Addendum

Florida Gateway College
New Building 102 – STEM Two
FGC ITB # ST-24-01-06
Lake City, Florida

03

May 17, 2024

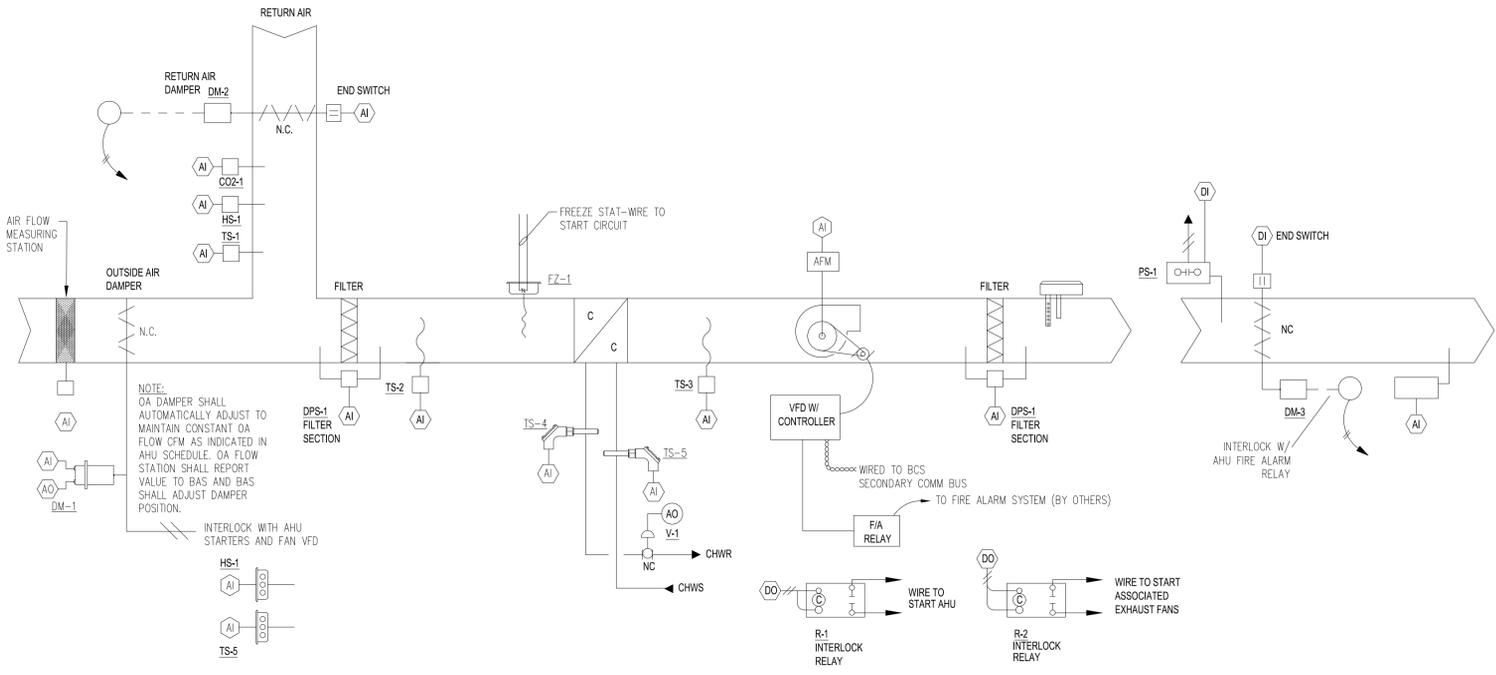
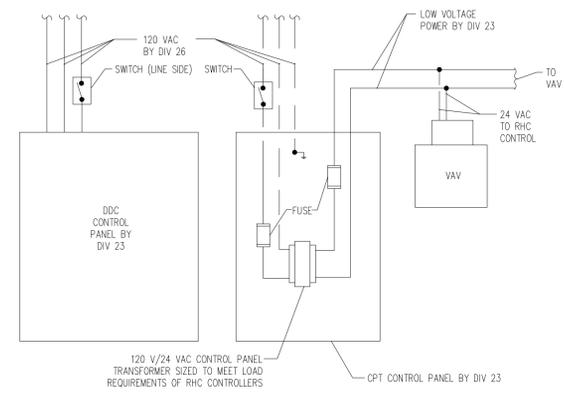
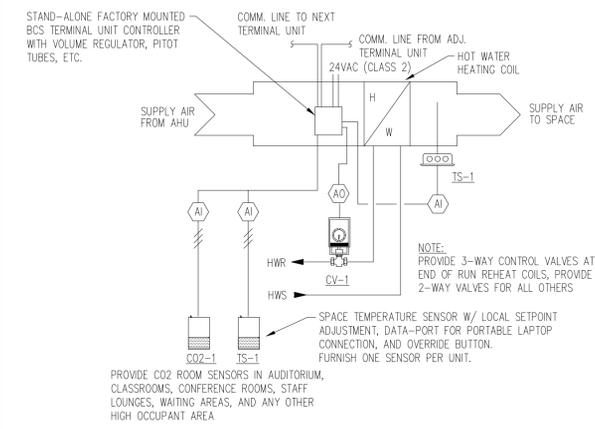
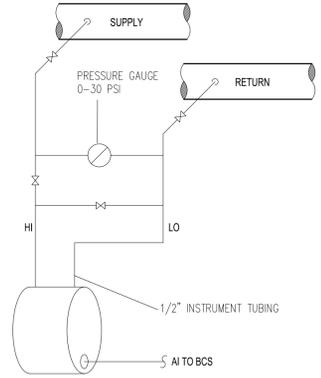
2. **DRAWINGS, SHEET M502 – HVAC CONTROLS:** Refer to the attached reissued Sheet. Revisions are indicated by revision triangle and clouding.
3. **DRAWINGS, MECHANICAL – GENERAL:** For clarification, the basis of design for the HVAC systems is Trane as indicated on the HVAC schedule sheets. Acceptable alternate manufacturers for the HVAC equipment are Carrier and Daikan. The controls system will be an extension of the existing Siemens system.

ALL NEW CONTROL POINTS SHALL BE CONNECTED TO THE EXISTING SIEMENS BUILDING AUTOMATION SYSTEM AND SHALL BE FULLY MONITORABLE AND ADJUSTABLE FROM THE EXISTING FRONT END LOCATED IN EXISTING ENGINEERING OFFICE. SIEMENS SHALL BE UTILIZED FOR THE CONTROLS CONTRACTOR FOR THE PROJECT. CONTROLS CONTRACTOR SHALL ADD NEW CHILLED WATER AIR HANDLING UNITS TO THE EXISTING SIEMENS DEMAND FLOW SYSTEM AND UPDATE GRAPHICS / ADJUST PLANT BASED ON THE NEW FACILITY.
